UNITED STATES PATENT AND TRADEMARK OFFICE

APPLICATION NO.	FILING DATE	FIRST NAMED INVENTOR	ATTORNEY DOCKET NO.	CONFIRMATION NO.
10/593,718	09/21/2006	Dani Markbreit	1412MUL-US	3119
32964	7590	11/26/2008	EXAMINER	
DEKEL PATENT LTD., DAVID KLEIN BEIT HAROFIM 18 MENUHA VENAHALA STREET, ROOM 27 REHOVOT, 76209 ISRAEL			FULTON, KRISTINA ROSE	
ART UNIT		PAPER NUMBER		3673
MAIL DATE		DELIVERY MODE		PAPER
11/26/2008

Office Action Summary	Application No.	Applicant(s)
	10/593,718	MARKBREIT ET AL.
	Examiner	Art Unit
	KRISTINA R. FULTON	3673

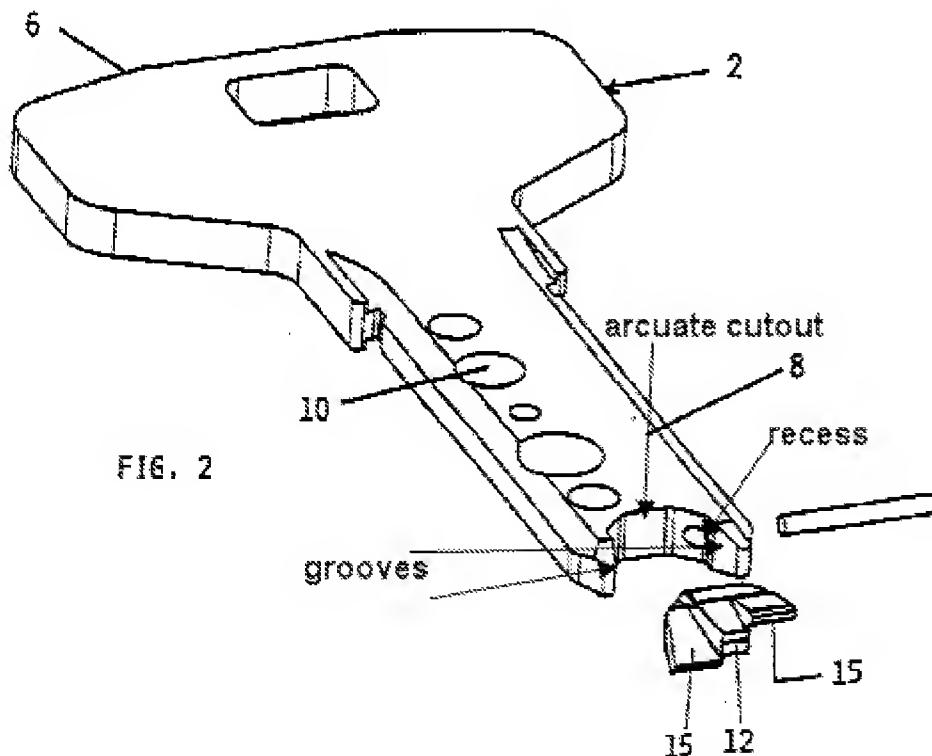
7. Regarding claims 2 and 6, at least one key combination element (12) pivotable about a pivot axis (see pivot axis in figure 2 below) and movably disposed in the elongate shaft portion.

8. Regarding claims 3 and 7, the at least one key combination element comprises a plurality of interface surfaces for urging at least one lock combination element (see figure 2 below where 12 has a plurality of surfaces 15 that urge a lock combination element).

11. Claims 4 and 8 are rejected under 35 U.S.C. 103(a) as being unpatentable over Botteon as applied to claims 1 and 5 above. Botteon teaches applicant's basic inventive concept including a key combination element (12) having a pair of arms (15) extending

from a common base which is pivotally mounted in an arcuate cutout (top portion of recess) extending from said recess, and wherein said recess is formed with grooves (see illustration below) radially emanating from the arcuate cutout, wherein walls of said grooves define limits of angular motion of said resilient arms. Botteon shows the element 12 having a pair of arms 15 but fails to disclose if resilient element 12' includes a pair of arms as well. It would have been obvious to one of ordinary skill in the art to include two resilient arms since Botteon discloses two arms (15) in a different embodiment. Including two arms provides a higher degree of security as stated in column 4, line 2. See the Botteon device below.
